BULLETIN

NUMBER 35

SUBJECT: Reinforcement of Windshield Attachment

MODELS AFFECTED: J3 Cubs, Serial Nos. 1999 to 6270 inclusive

ENCLOSURE FRAME REINFORCEMENT

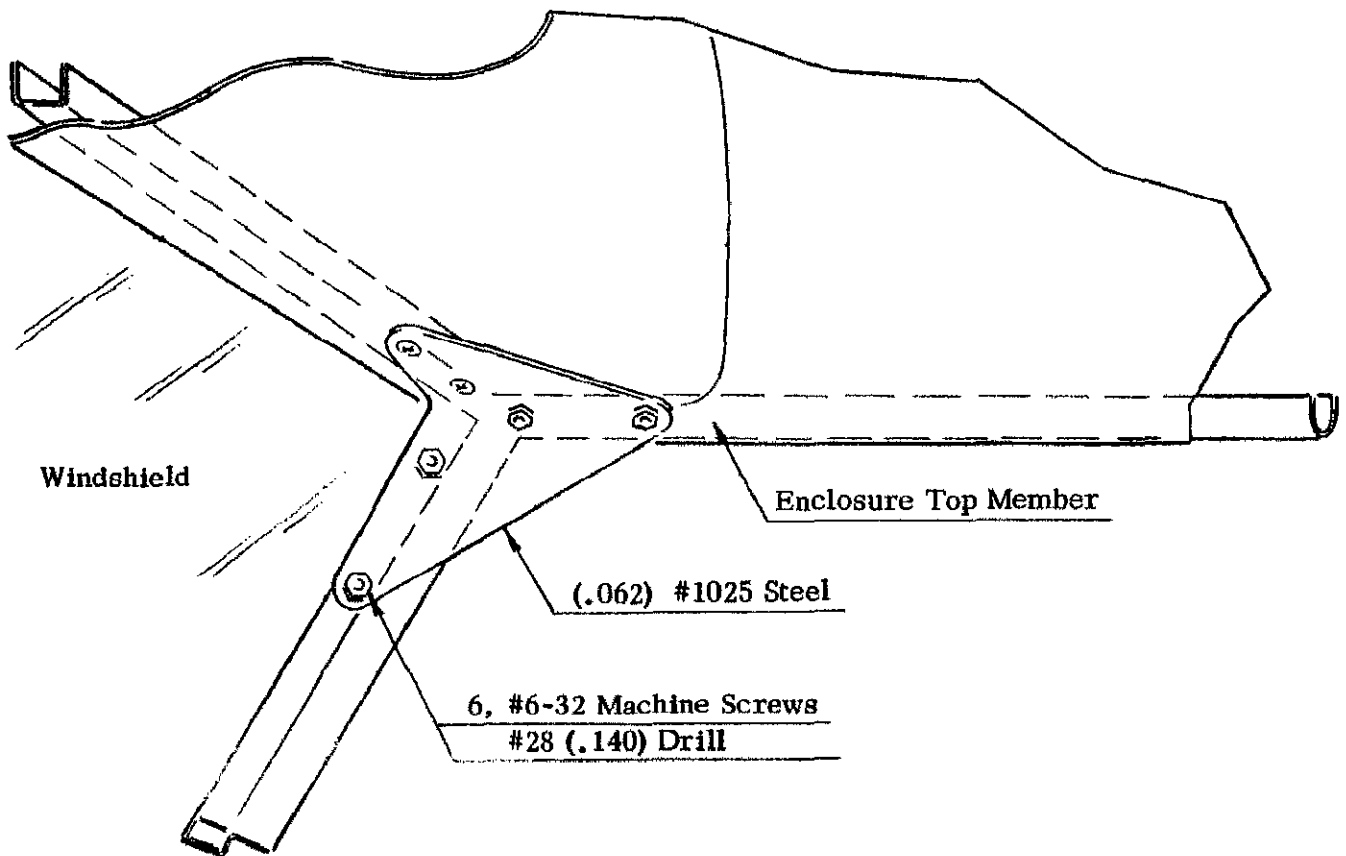
It has come to our attention that a number of cases of breakage have occurred in the welded joint at the intersection of the steel channels, to which the right rear edge of the windshield attaches, and the steel channel to which the hinges of the upper section of the cockpit enclosure attach. This junction is at the point where the upper edge of the windshield meets the lower surface of the wing.

These failures are due to buffetting of the enclosure during maneuvers and may also result from flying with the upper enclosure section opened against the lower surface of the wing.

While this failure will not necessarily result in an accident as the channels are installed only to supply support for the windshield and enclosure, continued operation with this joint broken may result in cracking of the windshield or loss of the enclosure. We strongly urge, therefore, that you install a reinforcing plate as shown on the attached sketch.

In order to make this installation, it is necessary to loosen the sheet metal cover over the front spar in the cockpit and also the upper section of the enclosure. Six holes (No. 28 drill) are then drilled through the three channels as shown and the reinforcing plate of 1/16" steel is then bolted in place with No. 6-32 machine screws, 3/4" long. Lockwasher should be used to prevent loosening of the nuts.
